Lost Creek

Proposal Clarifications

PROJECT: Lost Creek Resort Apartments at Lakewood Ranch

Project: Lost Creek Resort Apartments  
Location: Lakewood Ranch, FL  
Date Submitted: 01.12.2011  
Submitted By: Ambling Construction

# MDF 500 SERIES FOOT & SHOWER TOWER SPECIFICATIONS

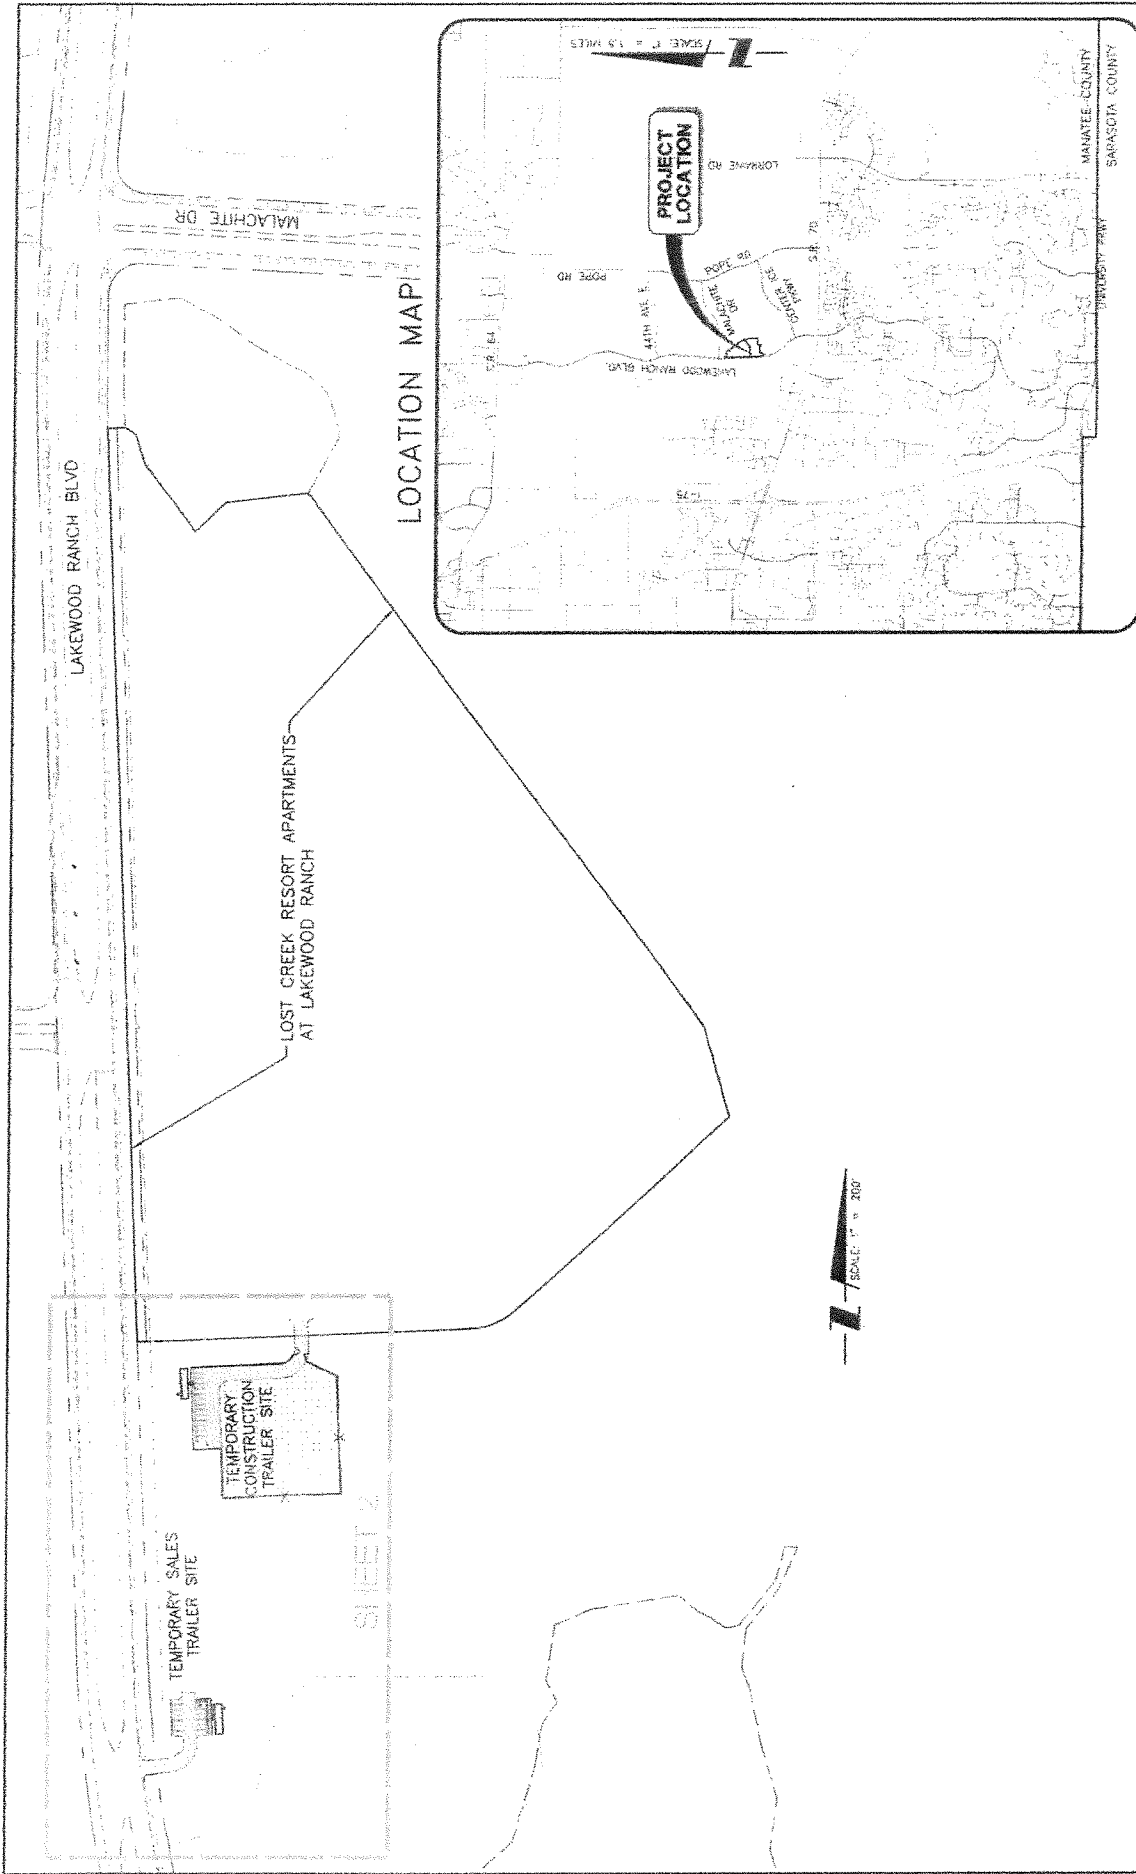
1. What is specification on the shower tower that was used at U.P.?

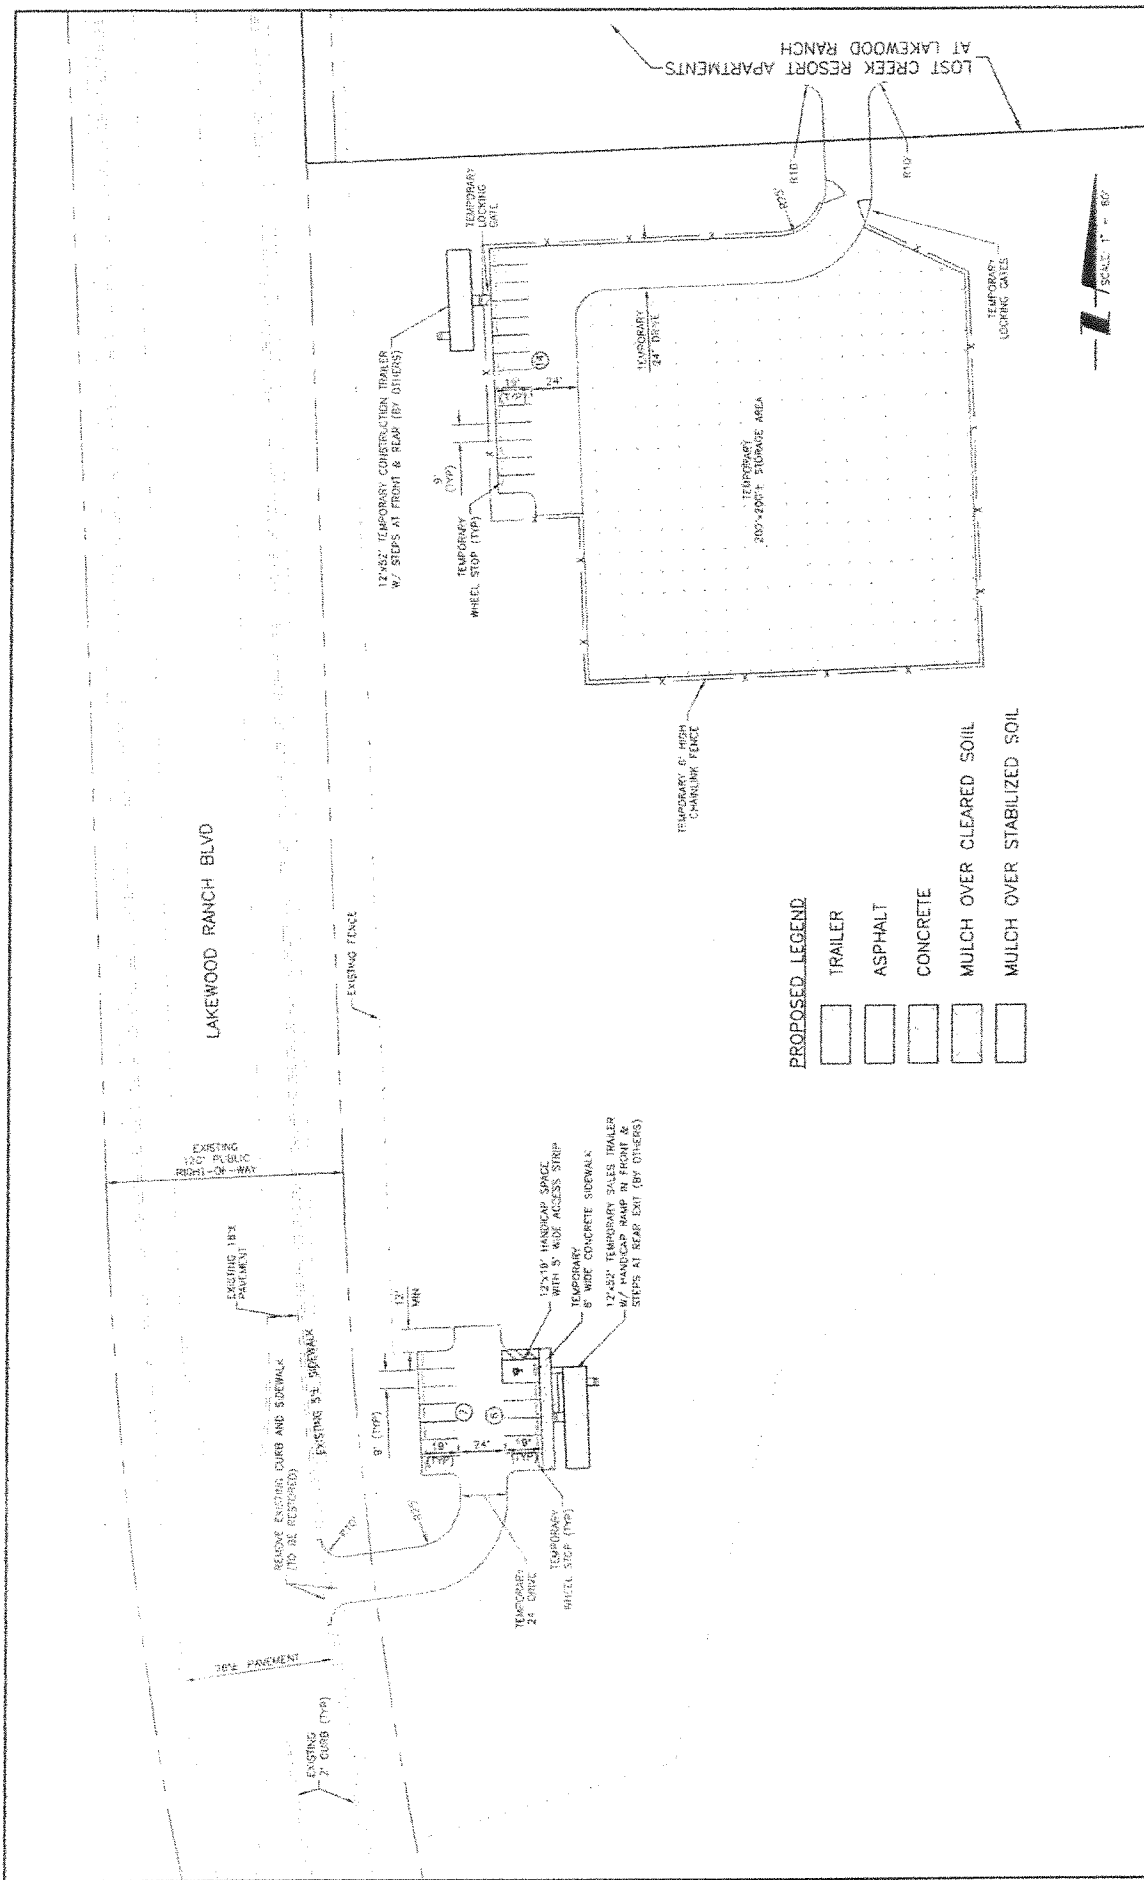
7. The 12.16.2011 cover letter from PAC identified a 14 acre parcel of land adjacent to the property to be used as a temporary staging area.
  - a. Please provide a boundary sketch that we may understand the property line relationship. *SEE Attached*

T-11

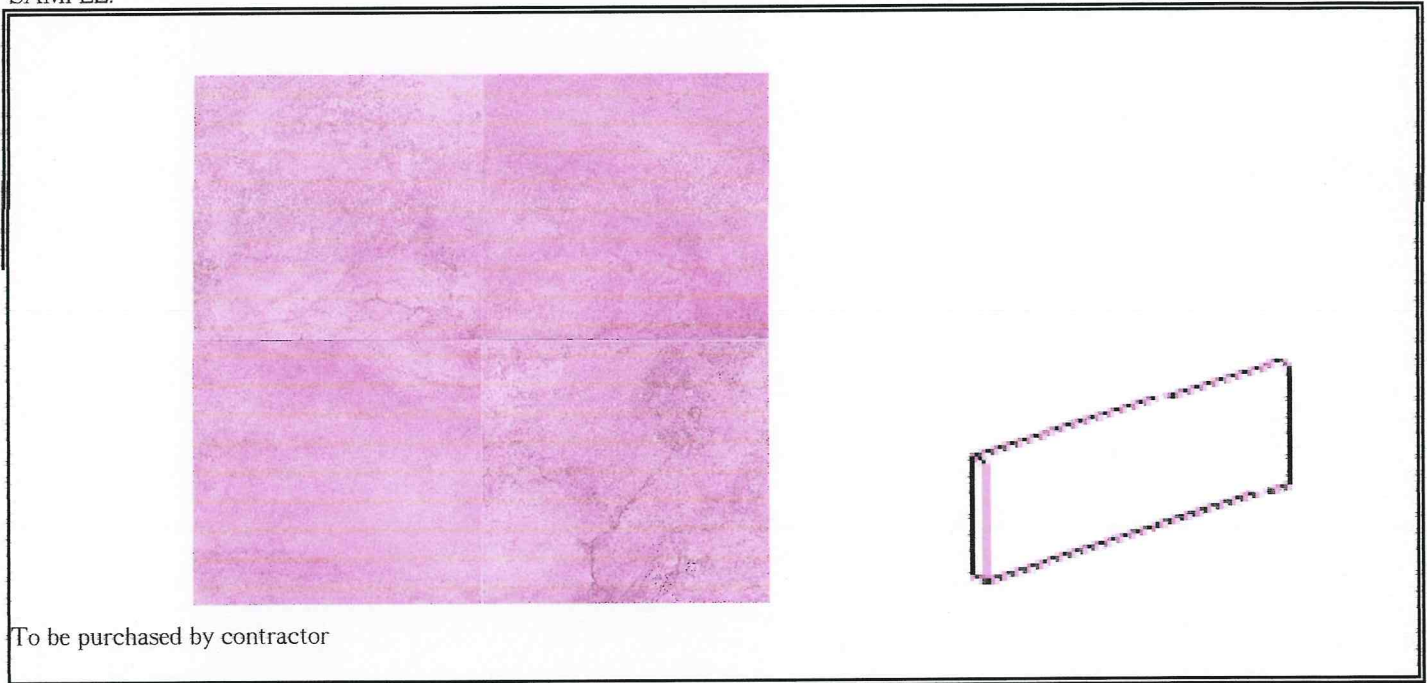
- 1) Tiles T-07, T-08, T-09, T-10, and T-11 have all been discontinued. These were from American Olean Tile and specified for rooms 100 and 101 in the clubhouse.

Please supply a reselection.
